Model: Adonis-C2		Date: 20-Sep-01	No.: RB003020
Subject: NCS(NIB) Firmware History		Prepared by: K. Takagi	
From: Technical Services Dept., GTS Division			
Classification:	<input type="checkbox"/> Troubleshooting <input type="checkbox"/> Part information <input checked="" type="checkbox"/> Action required <input type="checkbox"/> Mechanical <input type="checkbox"/> Electrical <input type="checkbox"/> Service manual revision <input type="checkbox"/> Paper path <input type="checkbox"/> Transmit/receive <input type="checkbox"/> Retrofit information <input checked="" type="checkbox"/> Other ()

Model: Adonis-C2		Date: 22-Oct-01	No.: RB003025
Subject: Service Card Release History (MFP)		Prepared by: K. Takagi	
From: Technical Services Dept., GTS Division			
Classification:	<input type="checkbox"/> Troubleshooting <input type="checkbox"/> Part information <input type="checkbox"/> Action required <input type="checkbox"/> Mechanical <input type="checkbox"/> Electrical <input type="checkbox"/> Service manual revision <input type="checkbox"/> Paper path <input type="checkbox"/> Transmit/receive <input type="checkbox"/> Retrofit information <input checked="" type="checkbox"/> Other ()

Model:

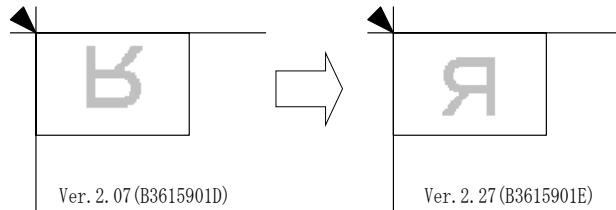
Descriptions	Version
<p><i>Firmware modified to correct the following:</i></p> <p>1. Software changed so that the original can be placed on the exposure glass just as with copying, i.e. there is no need to turn the original upside-down (for <u>both</u> directions).</p> <div data-bbox="316 751 928 959">  </div>	2.27
<p>2. Mixed Original Mode can now be used with the Twain driver ver.3.12. When using this driver, please note the following:</p> <ol style="list-style-type: none"> 1. Be sure to use Netfile software ver.2.17 or newer. 2. Also, be sure to install ADF ROM ver.1.76 or newer, as older versions will cause image stretching along the sub-scan direction with 425dpi and 555-557dpi scanning. 	
<p>Firmware modified to correct the following:</p> <p>1. The mainframe stalls if it receives the command to store a document while in the process of deleting another document. Application used: Desktop Binder V2.</p>	2.07
